# DPPS - detection area

IWG-DPPS-11-06  
(OICA / ACEA draft)

# Same vehicle with same shape (front face):

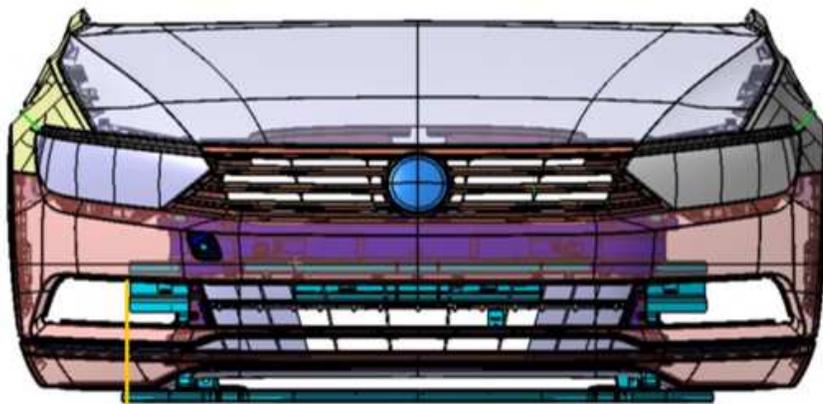
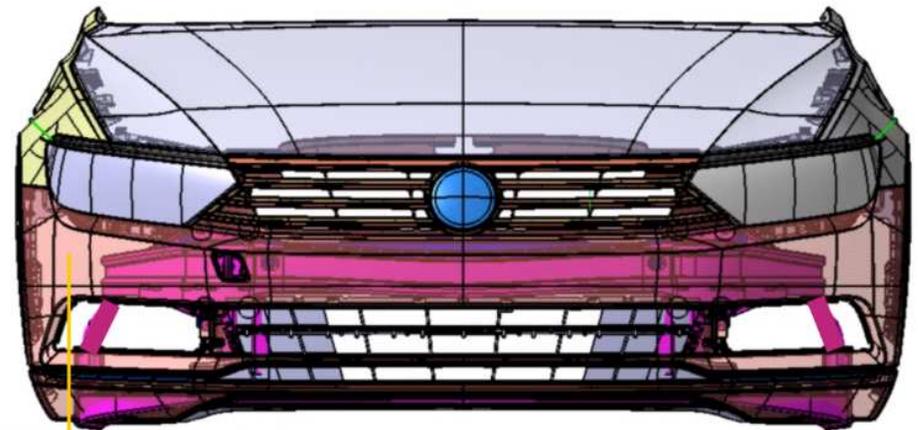
Why should the sensing width change when the exterior stays the same?

- The scope of the BTA is to ensure a pedestrian's leg to be protected from hard underlying structure, tested by a normalized lower Leg impactor.
- The scope of the Detection area is to ensure a minimum width of the vehicle to enable a deployment of the DPPS.
- The two scopes have no correlation in meaning nor pedestrian protection mechanism and should therefore be separated in the DPPS requirements.

3. "Detection area" is the area designated to detect a pedestrian in order to initiate the activation of the deployable system. The width of the detection area shall be the relevant vehicle width, minus a distance from each side of max of 12,5% of the relevant vehicle width, but not more than 250mm. ~~The detection area must not be smaller than the bumper test area (BTA).~~

- ~~1) Outer most of bumper test area~~
- 2) Vehicle width at front wheel center minus 12.5% of the width
- 3) Vehicle width at front wheel center minus 250mm
